# PITT ST SOUTH

OVER STATION DEVELOPMENT

RESPONSE TO SUBMISSIONS

SEPTEMBER 2020

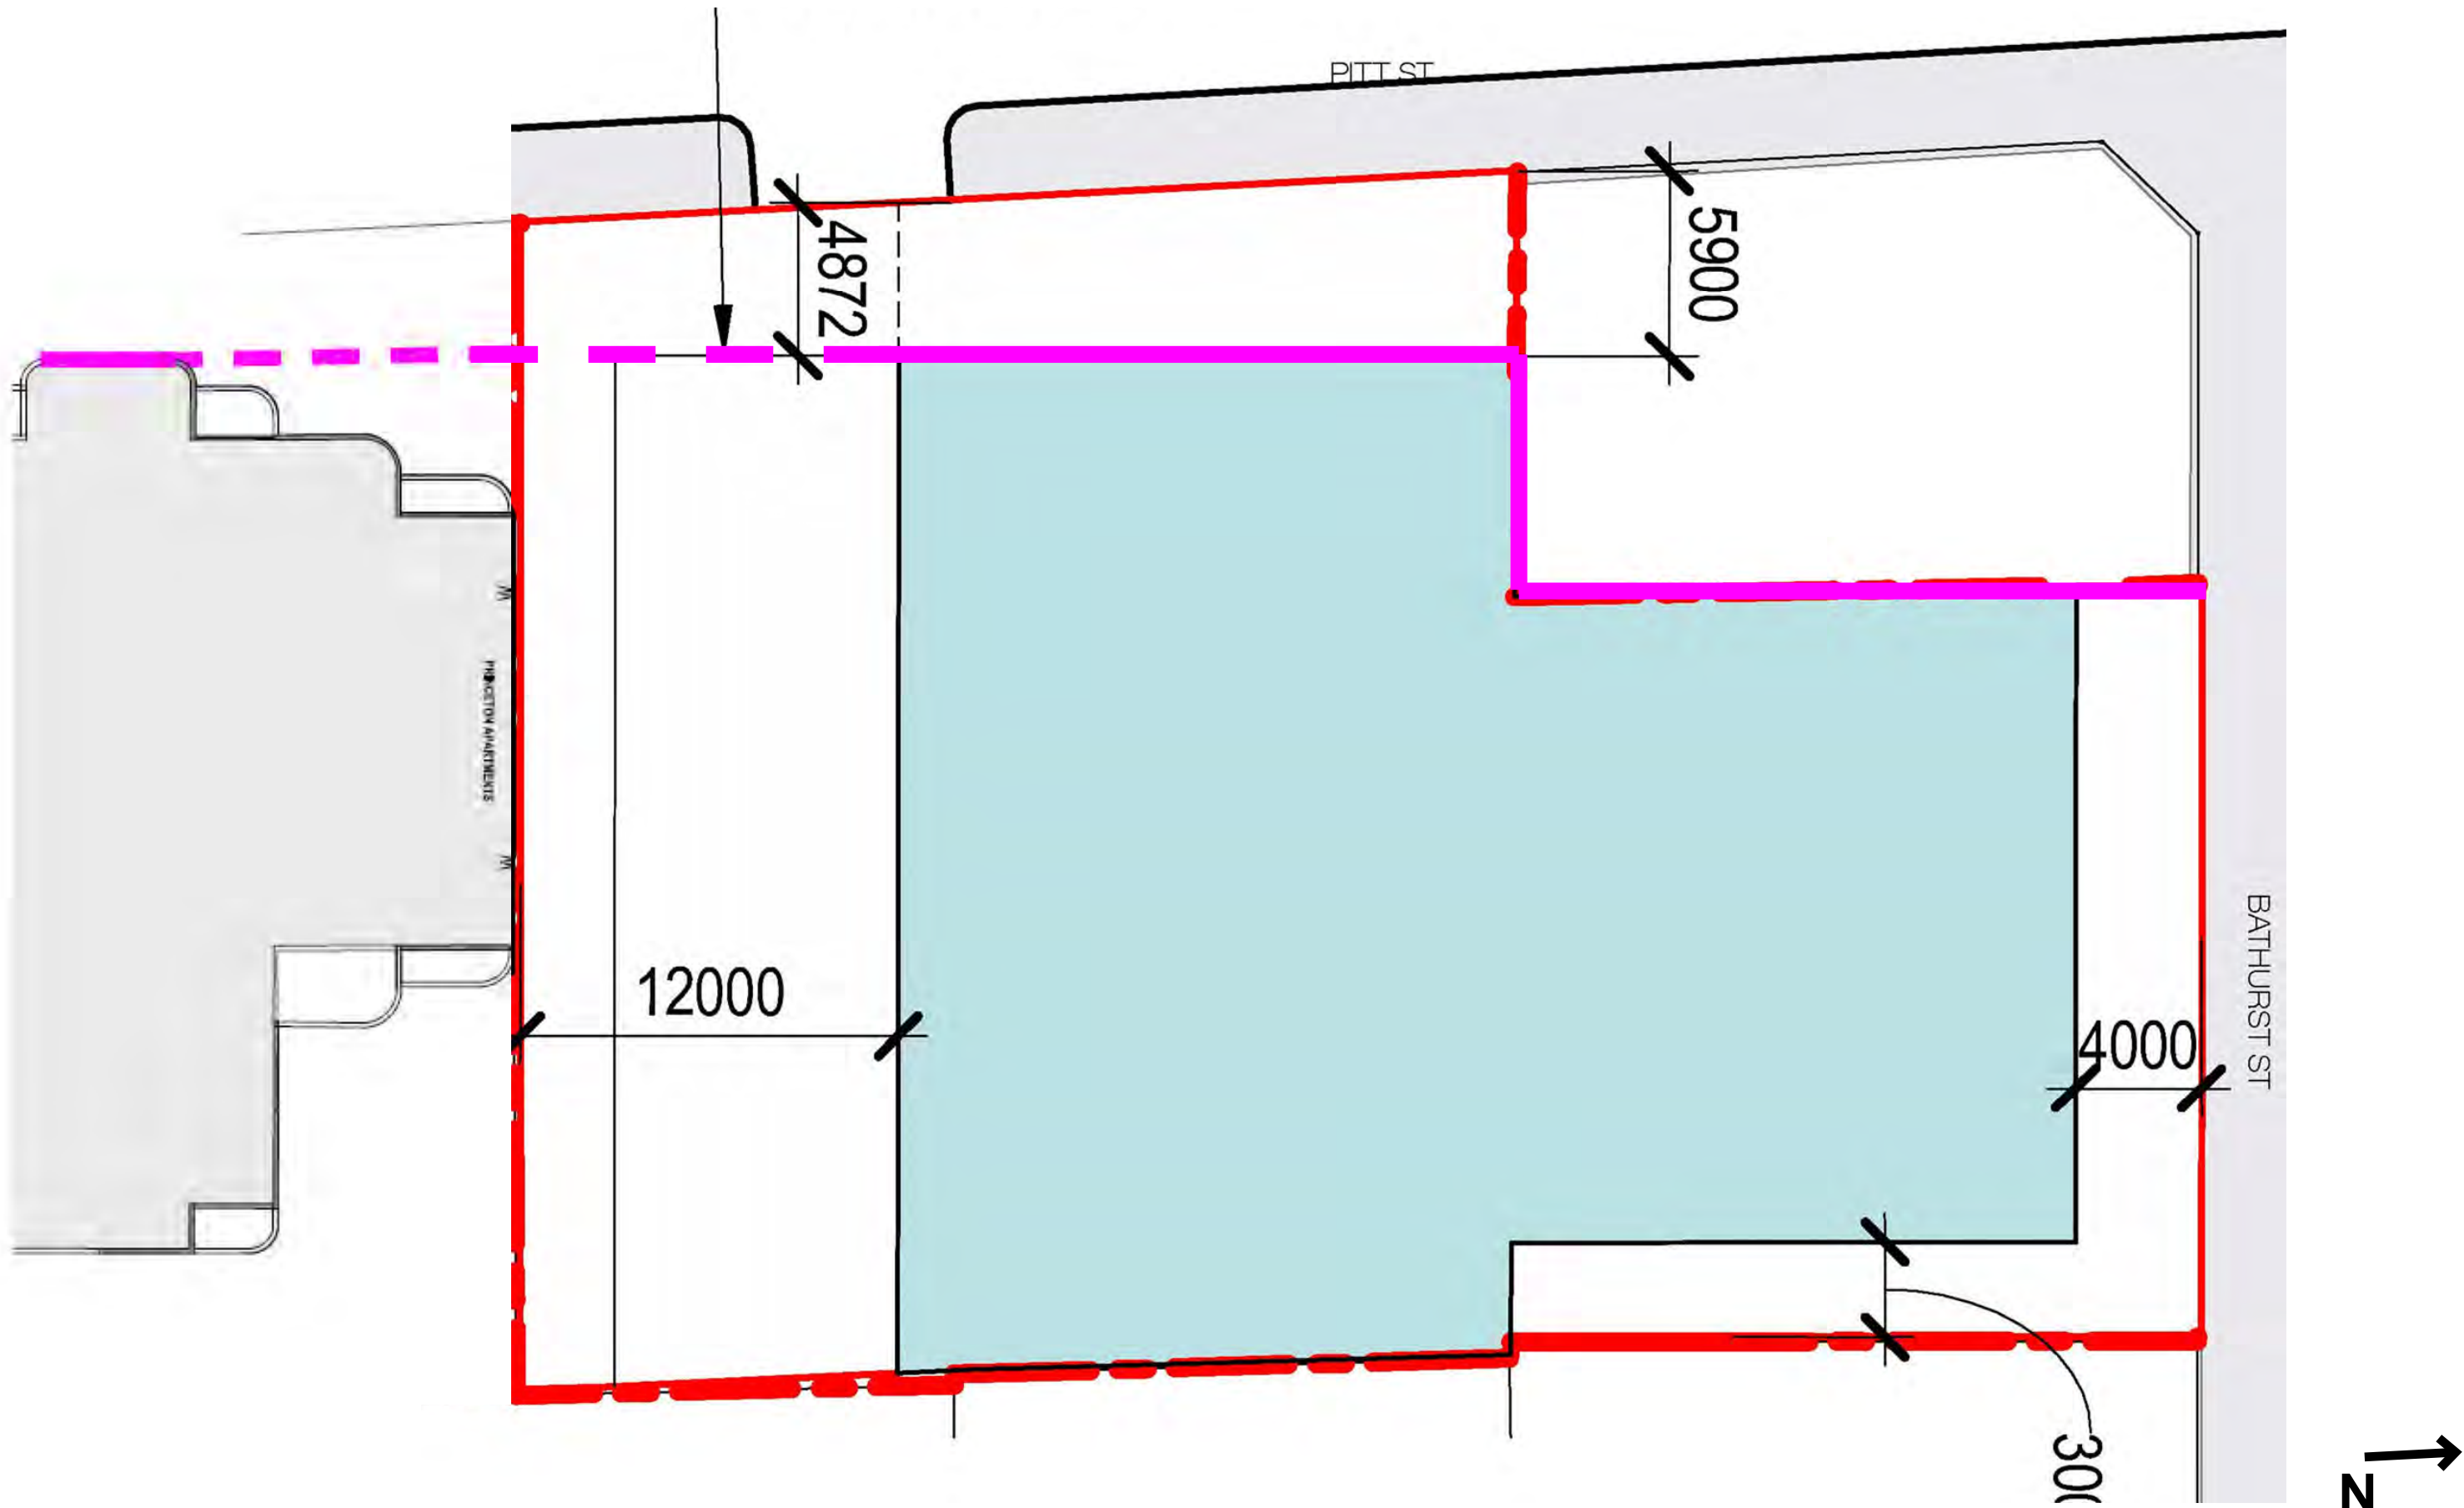
*(a) Demonstrate compliance with Condition B3 of the Concept Approval, and provide detailed illustrations showing how the proposed built form satisfies the following subclauses:*

*\* (e) a varied setback from the Pitt Street boundary of the site, with the articulation of built forms be designed to minimise solar impacts to the living rooms of Princeton Apartments*

The adjacent drawing shows the setback to Pitt Street as approved in the Approved Concept Envelope stamped plans.

The approved setback is varied from the Pitt St Boundary and aligns with the setbacks for Princeton Apartments, as indicated by the note and dimensions on the stamped drawing.

The purple line (added) shows the variety in setback along this frontage for comparison with our Stage 2 proposal as lodged (overleaf).

## RESULTING PITT STREET SETBACK

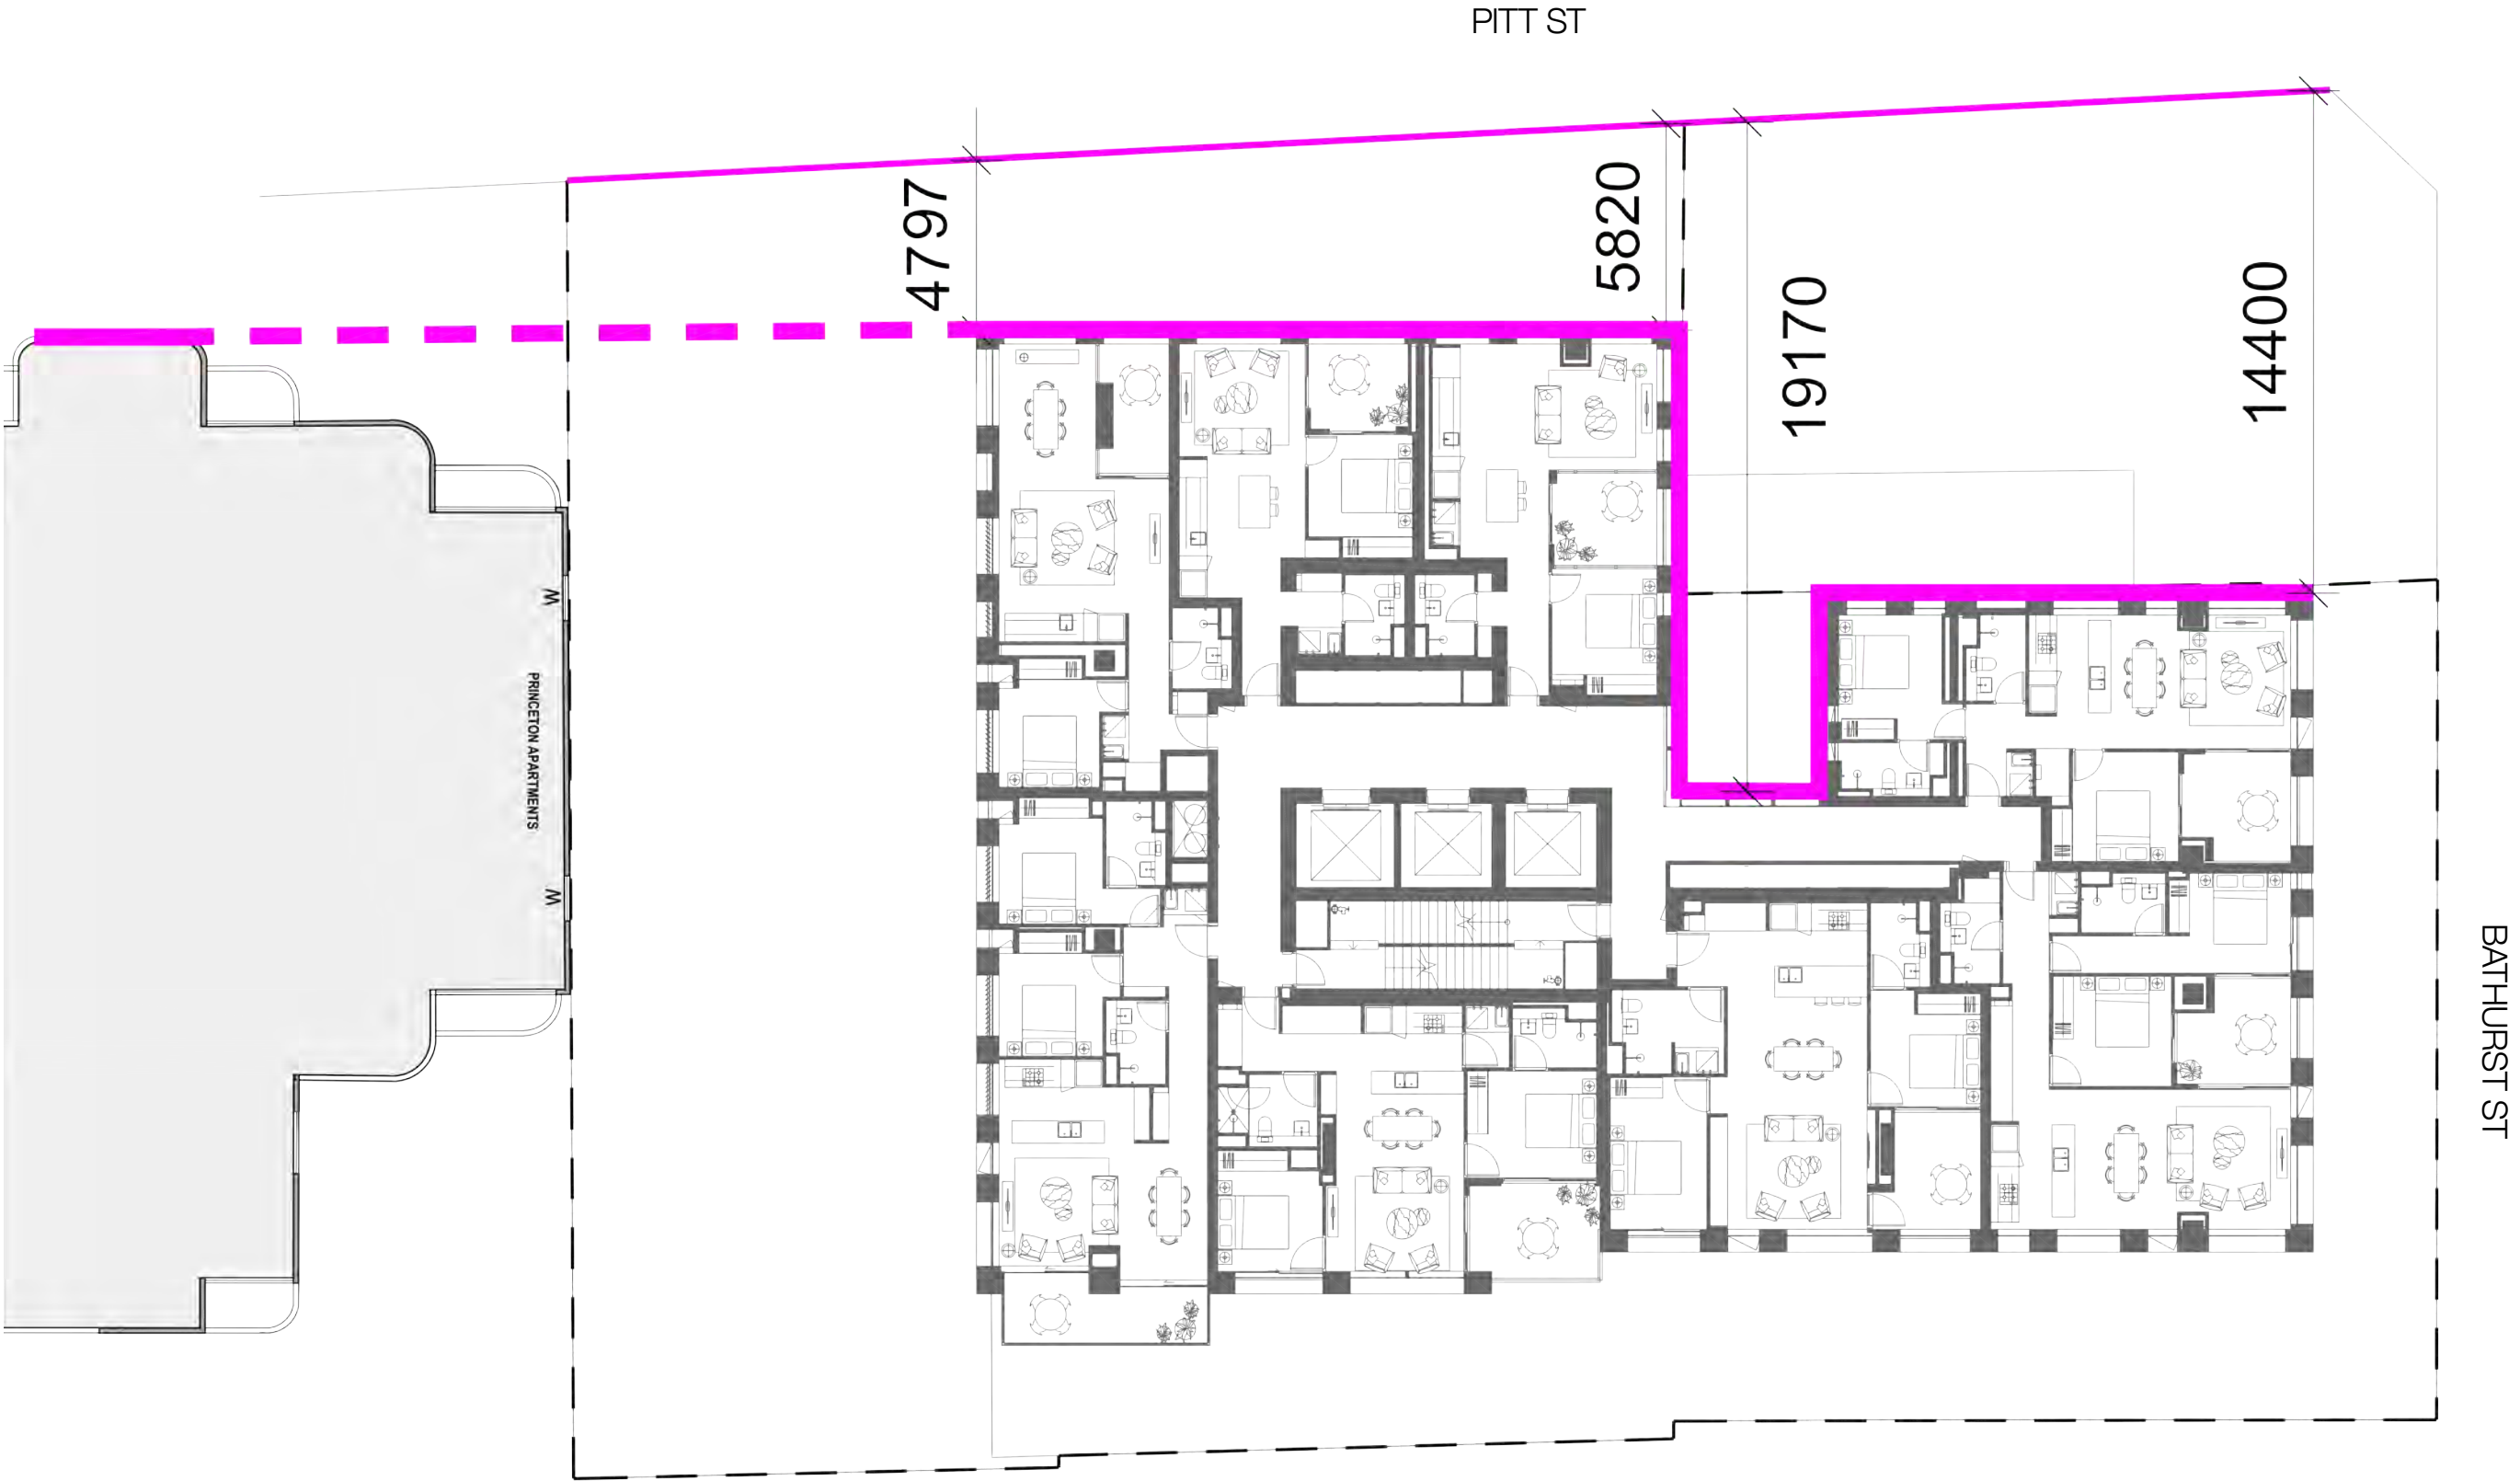
*(a) Demonstrate compliance with Condition B3 of the Concept Approval, and provide detailed illustrations showing how the proposed built form satisfies the following subclauses:*

The resulting proposed setback to Pitt Street is 4.797m at the South West corner, increased from 4.63m.
